Edwin I. Hatch Nuclear Plant
Reply to a Notice of Violation

Enclosure: Violation 96-14-03 and GPC Response

Edwin I. Hatch Nuclear Plant
Violation 96-14-03 and GPC Response

VIOLATION 96-14-03

Figure 1
Actual Appearance of
Selector Switch Face

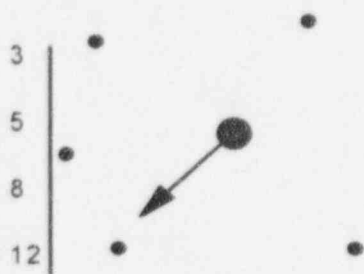
The fourth example of the Notice of Violation was caused by an inadequate breaker trip device label. Specifically, the manufacturer-installed labels on the face of the breaker trip device selector switch are misleading. An individual setting the trip device to point to the numeral 12 on the face of the selector switch would actually be setting it to a dot corresponding to an incorrect trip setpoint of 8X instead of the desired setpoint of 12X. (Comparing Figure 1 with Figure 2 shows the labeling problem which led to the breaker trip device being set incorrectly.) The inadequate label resulted in the installed overcurrent trip device for the normal supply breaker to Motor Control Center 1R24-S026 having a setting which differed from the electrical single line diagram and from procedure 52PM-R24-002-0S, "Air Circuit Breaker, Type LA-600, Maintenance," both of which required a trip setpoint of 12X.

For the fourth example, a temporary modification was implemented on 11/10/96 in which a 150-amp, non-safety related load was removed from Unit 1 Motor Control Center 1R24-S026 and powered from another bus. The incorrectly set trip device installed on the

600V feeder breaker in Motor Control Center 1R24-S026 then was disabled and the appropriate breakers set to accommodate the remaining loads on the bus. These actions were taken in response to potential concerns regarding proper breaker coordination with the instantaneous overcurrent trip device installed and resulted in the "B" Emergency Diesel Generator being returned to operable status. Breaker settings for similar breakers in the plant have been checked by the system engineer; they were found to be correct.
